6-19-84

In Reply Refer To:
Dockets: 50-445
50-446

The attached enclosures are matters relating to alleged improper construction practices involving the Comanche Peak Steam Electric Station main condensers (Units 1 and 2) expressed by an alleger during an interview conducted on August 24, 1983 by members of the NRC Office of Investigation Field Office, Region IV. Although the condenser units are components within the BOP classification, the allegations expressed raise concern as to the quality of workmanship that could impact on reactor safety.

You are requested to provide this office in writing within 20 days, your assessment of the extent that your quality control program was previously implemented during condenser unit fabrication and installation; a summary of test results that will reflect existing leak rates; and an evaluation of the impact of any expected condenser tube leakage on your ability to maintain satisfactory steam generator secondary side water chemistry.

9 ██████████ Exhibit 1 just referred to
10 follows.)

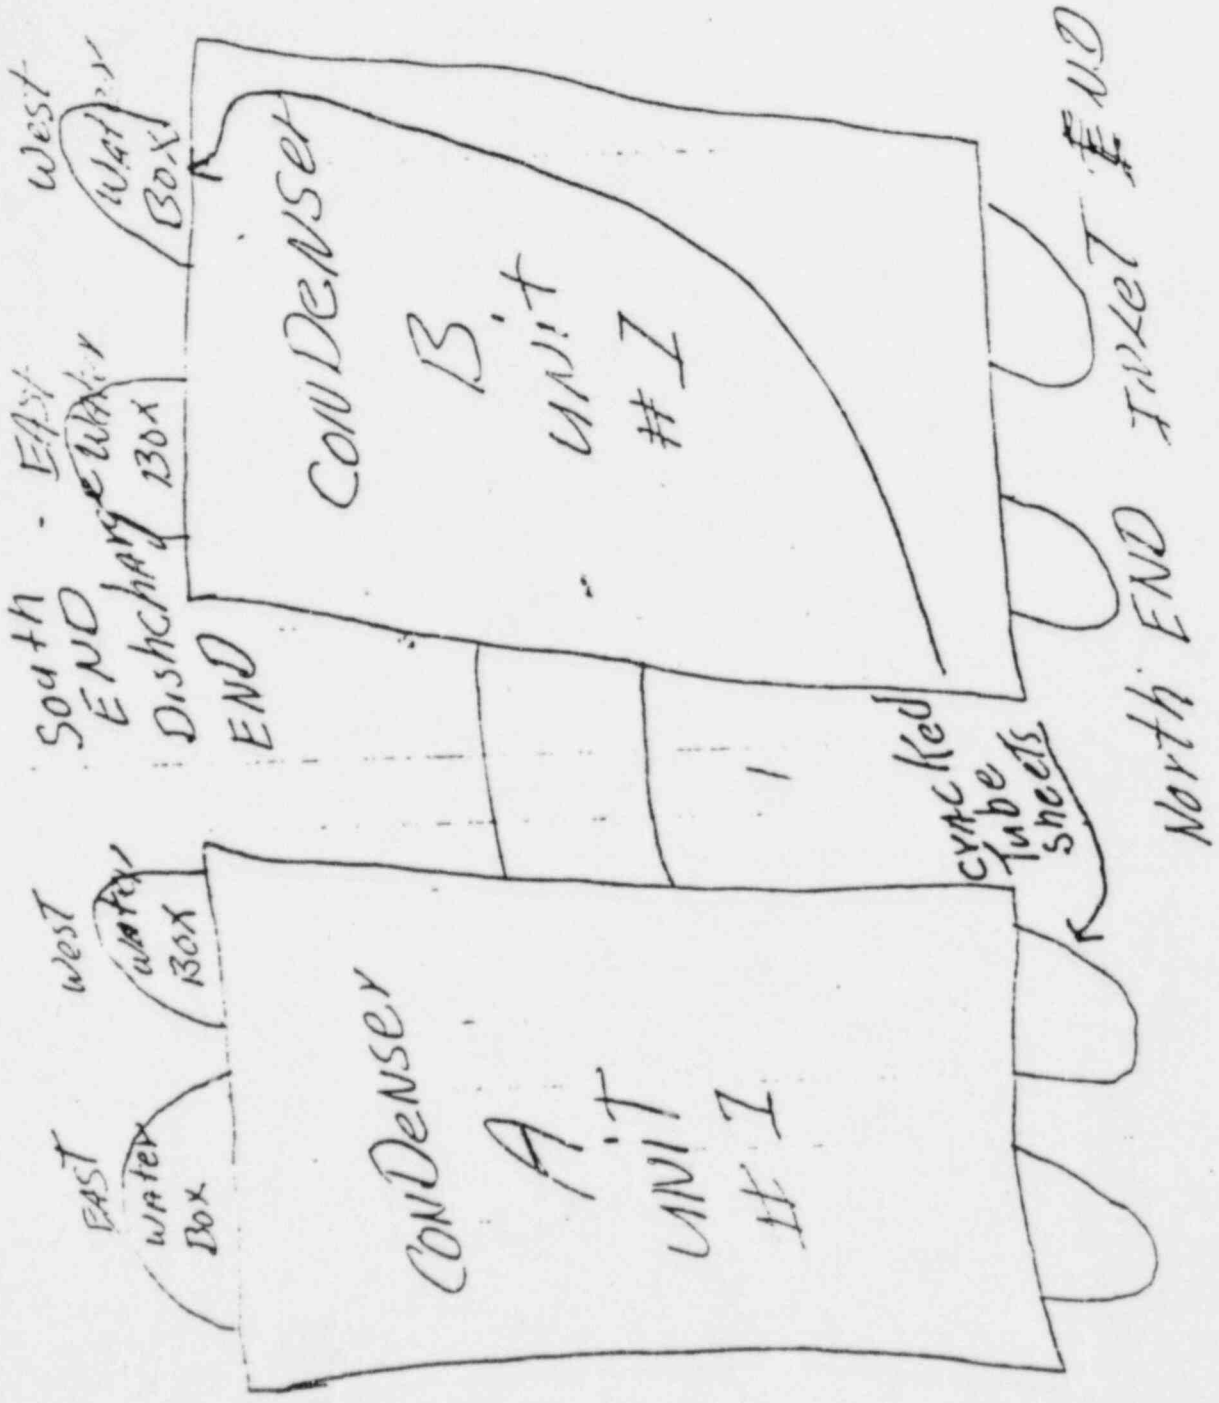
15 Here is your water boxes right here and your
16 condensers. All right, in condenser A on the inlet end on
17 the west box and it is in three sections. You have got
18 some cracked tube sheets in here. Back there you have got
19 some cracked tube sheets. You have got overrolled tubes or
20 barely overrolled. They are supposed to be rolled 069
21 thousand is a perfect roll inside reading. They allow us
22 to go to 071 thousand. We went up 90-some thousands.

12 [REDACTED] Okay. Condenser B, Unit 1,
13 west discharge water box and you have got a cracked tube
14 sheet. Also, the tubes are overrolled severely.

15 On the east water box, condenser B, discharge
16 end, you are heavily overrolled and you undoubtedly have
17 got quite a few cracks in it. I can swear to that. I know
18 you do because it swelled up so big.

19 Overroll on the west box, condenser A, Unit 1,
20 discharge end.

21 East water box, discharge end, condenser A,
22 you are still leaking, and overrolled.

2 Condenser A, Unit 1, intake box, the west box,
3 you have got cracked tube sheets.

12 ([REDACTED] Exhibit 2, the document just
13 referred to, follows:)

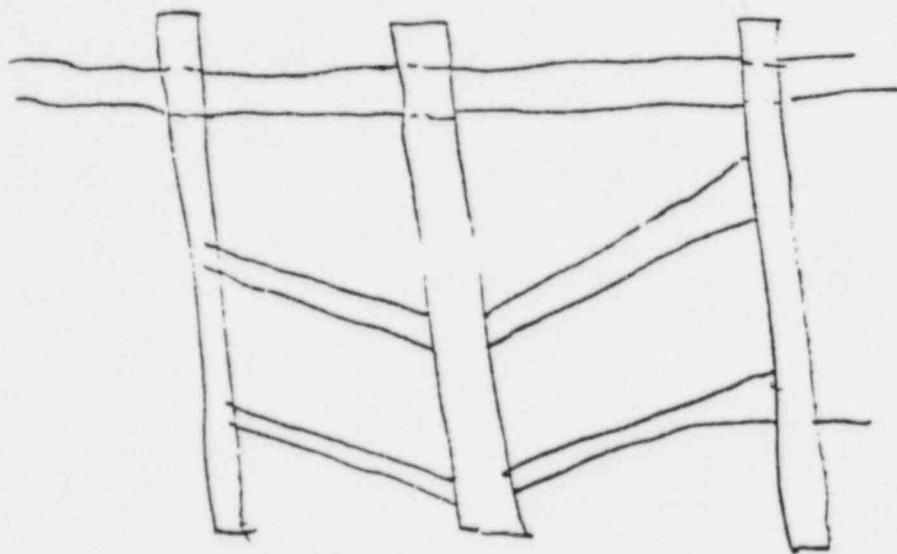
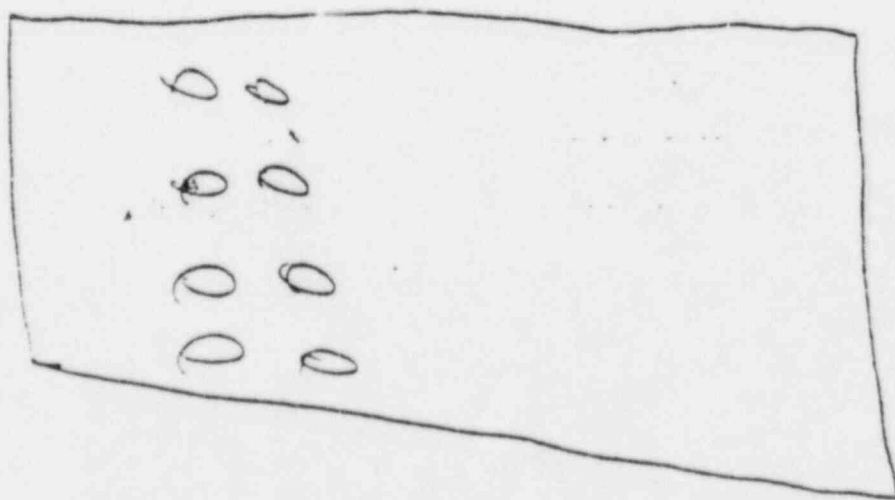
This is a real good example. These tube
support sheets came in. We laid them on top of each other
and we put dowel pins in them. Some of the holes was
three-eighths of an inch off from the others, you know.

So I called [REDACTED] and I told him, I said we
are going to have a problem here. These holes are way off.
Well, he calls Westinghouse, and Westinghouse says oh,
there is nothing to it. [REDACTED] says, [REDACTED], they are just
three-eighths of an inch off. I said well, you have got
three foot from the center of one sheet to the other, and
when you start off with three-eighths of an inch off you
are off quite a ways when you get to the other end, you
know, the three foot.

If you go three-eighths of an inch off, over
here you might be an inch and a half off, and by the time
you turn it back in then automatically you are going to
head the other way. So you are binding every sheet. You
are cutting into the tubes.

4 [REDACTED]: This is Unit 1 and Unit 2 A
5 and B condensers, the main condensers. This is what I am
6 talking about. I am not talking nothing about the
7 Auxiliary condenser. Everything is the main condensers.
8 There is supposed to be something like 39 thousand
9 clearance in the tube support sheets so that your tubes
10 can expand in its track without binding. Now your main
11 tube sheet is 10 thousand before they roll these.

([REDACTED] Exhibit 3, the document just
referred to, follows:)

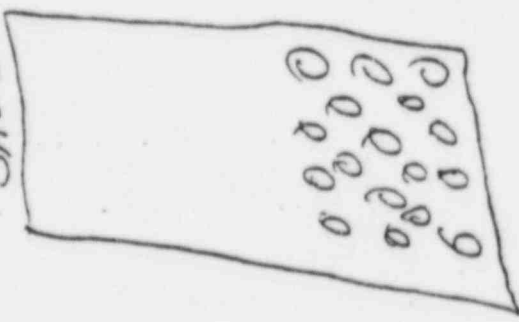
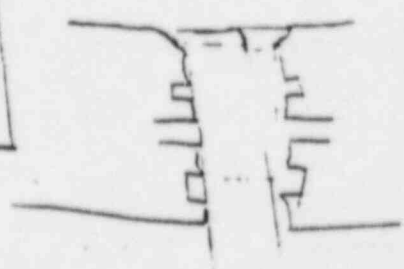
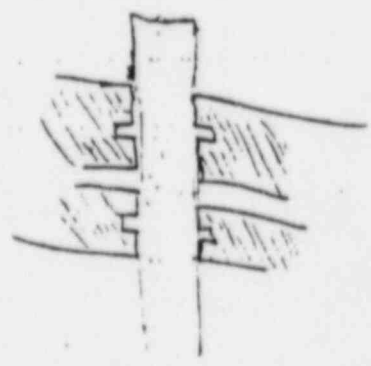
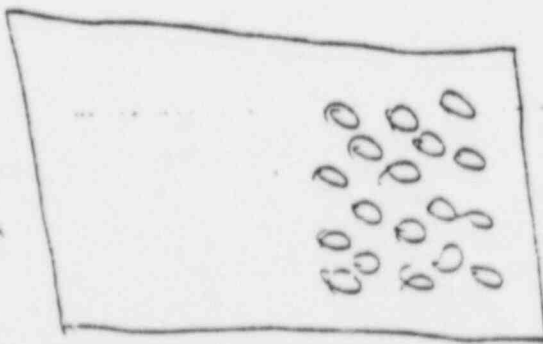
5 [REDACTED]: On your inlet tube sheets.
6 They are 1/32nd flush, the tubes, and they are flared. If
7 they are sticking out, you get a build-up between your
8 tubes. So when we flared these we busted a lot of tubes,
9 or quite a few of them as a matter of fact.

10 Now this chart, and it sticks out, but we cut
11 them down like a half inch so it would look half way
12 decent. But when we was flaring these tubes they was
13 busting pretty bad, and the reason they was busted so bad
14 in this one area is because the counterbore in your tube
15 sheet where it allows the flare to flare out was way
16 overboard. So in order for us to flare it tight enough we
17 busted a tube, and the ones that didn't bust we hadn't
18 flared it tight enough. When you don't flare them tight
19 enough you get a build-up between your sheet and your
20 tubes and it eats the tube off.

([REDACTED] Exhibit 4 follows:)

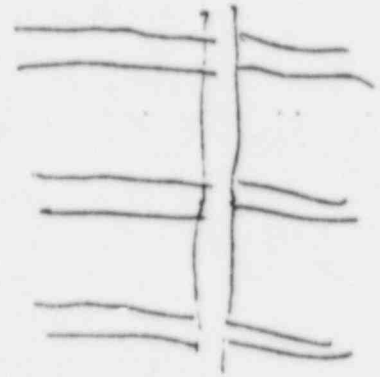
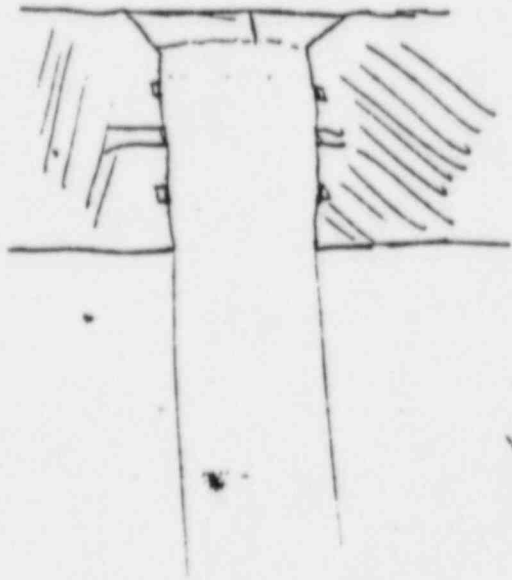
[REDACTED]: We have got cracks here on these flares.

[REDACTED]: Yes, Glen Rose, Texas at Comanche Peak. Most of them is in condenser A on the inlet end east water box middle way of the sheet.

([REDACTED] Exhibit 5A and 5B follows:)

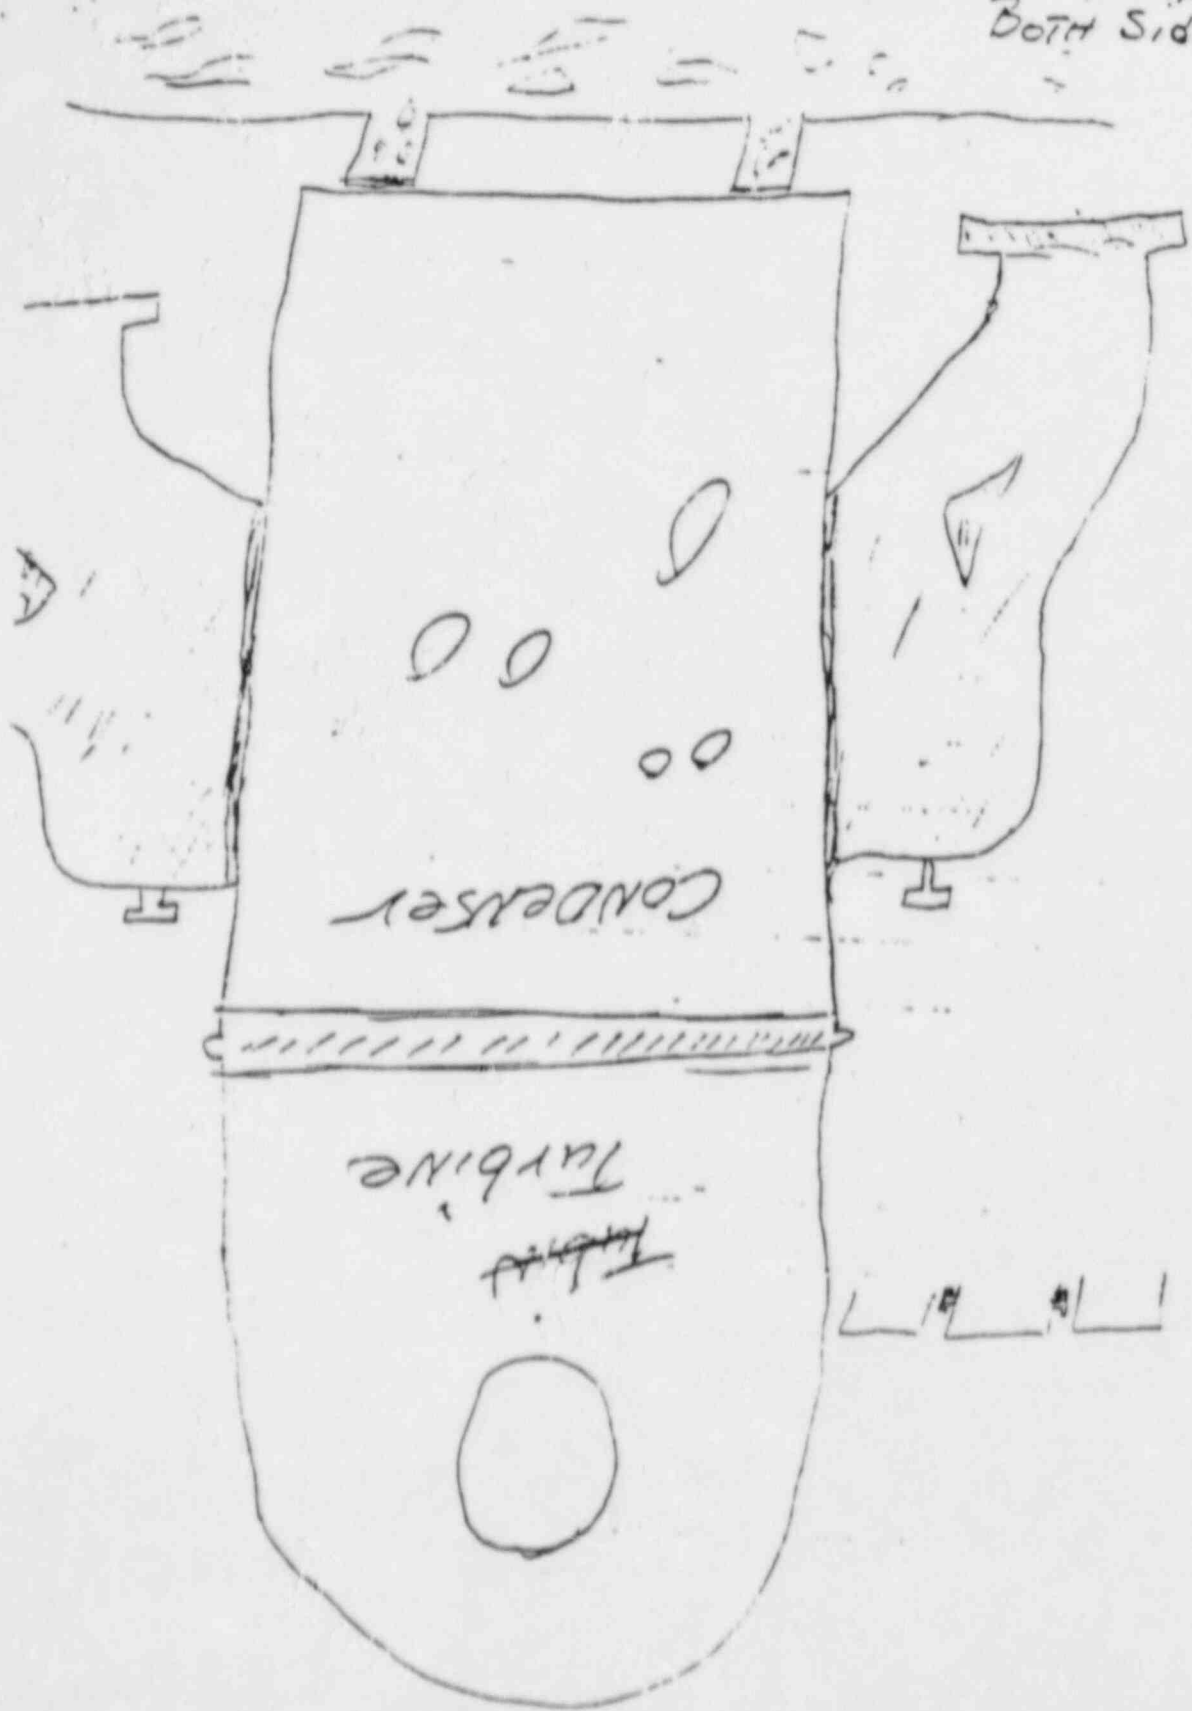
They took a reading and they was three-eighths of an inch off alignment. So they went up here and they took jacks and they started jacking and, boy, jacked it all the way over to where they want it and they release it, that little old expansion joint, and pulled it back. The little expansion joint was a one loop and it was an eighth of an inch thick and it had one little fillet weld on each side of it, real weak. They put several, several tons on it. I will show you what it looked like.

4 [REDACTED]: (Referring to Exhibit 5B) Oh,
5 this is the expansion joint I was talking about with the
6 fillet welds. It is a real small stainless steel 1/8th
7 expansion joint and it has got two small, little fillet
8 welds there.

11 [REDACTED]: We put several, several, I
12 think two or three hundred tons against it.
